Access Compliance Report

Public Rights-of-Way

(Curb Ramps)

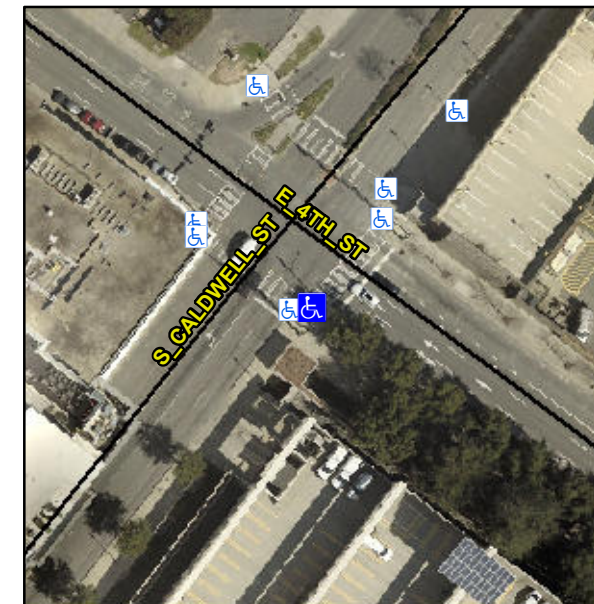
Intersection ID: N/A	Main Street: E_4TH_ST	Cross Street: S_CALDWELL_ST	Location: S
ADA ID: 1C0A400AA3BB	Ramp Type: Perp	Initial Pass/Fail: Fail	Overall Compliance: No
		Severity Score: 12.5	
Codes/Mitigation Info/Possible Solution		Field Measurements/Component Compliance

Not Found, R304.2.2

Compliance	Description	Data	Compliance	Description	Data
N/A	Ramp Length (in)	75.0	No	Ramp Slope (%)	8.9
Yes	Ramp Width (in)	48.0	Yes	Ramp XSlope (%)	0.0
N/A	Flare Type LT	N/A	N/A	Flare Type RT	N/A
N/A	Flare Slope LT (%)	N/A	N/A	Flare Slope RT (%)	N/A
N/A	Flare Traversable LT?	No	N/A	Flare Traversable RT?	No
N/A	Landing Length (in)	N/A	N/A	DWS Provided?	N/A
N/A	Landing Width (in)	N/A	N/A	DWS Contrast?	N/A
N/A	Landing Slope (%)	N/A	N/A	DWS Length (in)	N/A
N/A	Landing X Slope (%)	N/A	N/A	DWS Full Width?	N/A
N/A	Landing Curb? (Y/N)	N/A	N/A	DWS Offset (in)	N/A
N/A	Shared Landing?	N/A			
N/A	Gutter Ponding?	N/A	N/A	Gutter Slope (%)	N/A
N/A	Gutter Lip Ht (in)	N/A	N/A	Gutter X Slope (%)	N/A
N/A	Painted X Walk1?	Yes	N/A	Painted X Walk2?	N/A
	X Walk 1 Direction	To NE		X Walk 2 Direction	N/A
N/A	X Walk 1 Width (in)	120.0	N/A	X Walk 2 Width (in)	N/A
	X Walk 1 Slope (%)	4.8		X Walk 2 Slope (%)	N/A
	X Walk 1 X Slope (%)	0.7		X Walk 2 X Slope (%)	N/A

Remove & Replace Entire Ramp.
